Office Action Summary

10/823,510

This is a first office action on the merits of patent application S. N. 10/823,510.

FIG. 3

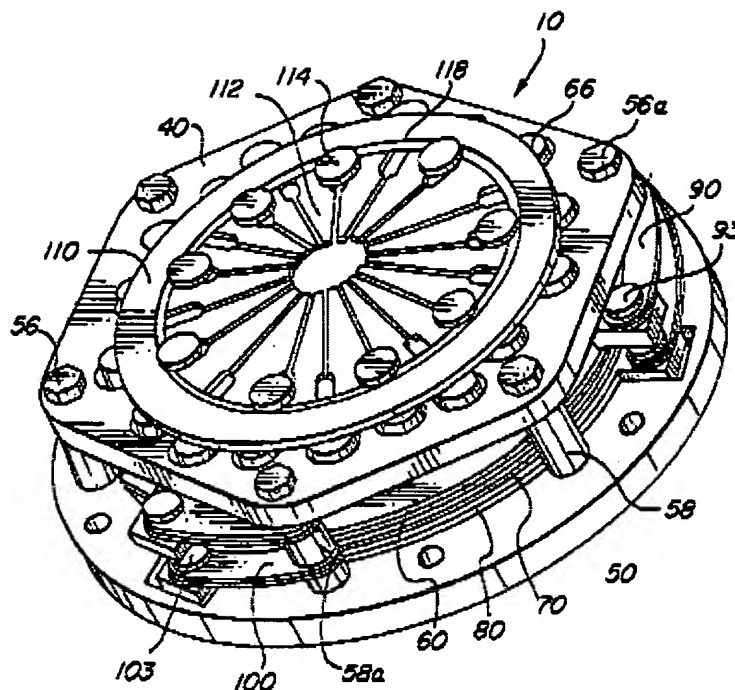
Claims 1-6 and 12 are rejected under 35 U.S.C. 102(b) as being anticipated by Mahoney ('786).

Mahoney discloses a dry multiple-disk clutch (Fig. 3) for transmitting power from a drive shaft (14) to a transmission input shaft (18) comprising an outer clutch member (40, 50, 58, 58a, 59), a plurality of driving friction disks (60, 80), a plurality of driven friction disks (70 – second disk not shown, see 4,977,991 upon which '786 improves) a pressure member (60, 66, 110), elastic strap plates (90, 100) with ends, external projections (62, 82), and studs (93, 103).

FIG. 7

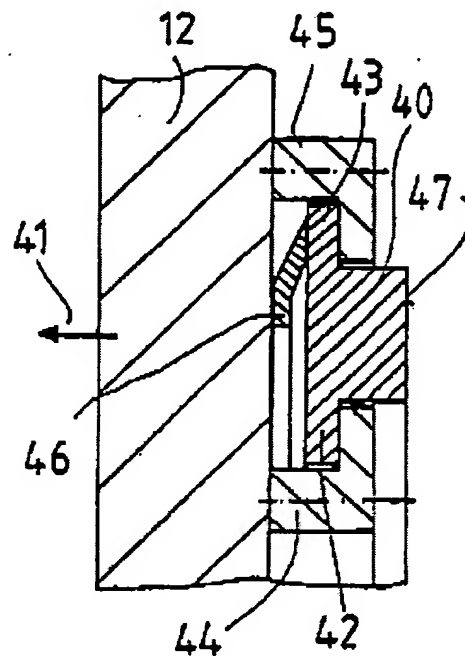
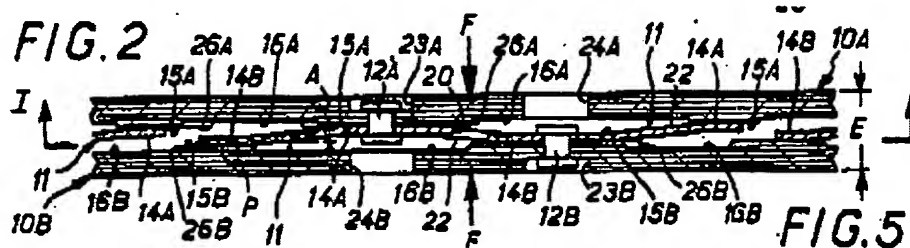
Claims 7-8 and 11 are rejected under 35 U.S.C. 103(a) as being unpatentable over Mahoney ('786) in view of Gonia et al. ('665).

Mahoney does not show vibration control means or the specifics of the flywheel. However, providing elastic means on outer clutch members is conventional in the clutch

art. For example, Gonia discloses an outer clutch member (12) having a vibration control element (46) or cone spring (Col. 7, lines 16-18) and a control plate (40).

Then, it would have been obvious to a person of ordinary skill in the art at the time the invention was made to provide a vibration control element as taught by Gonia in the device of Mahoney to dampen vibration and improve the progressiveness of the clutch engagement.
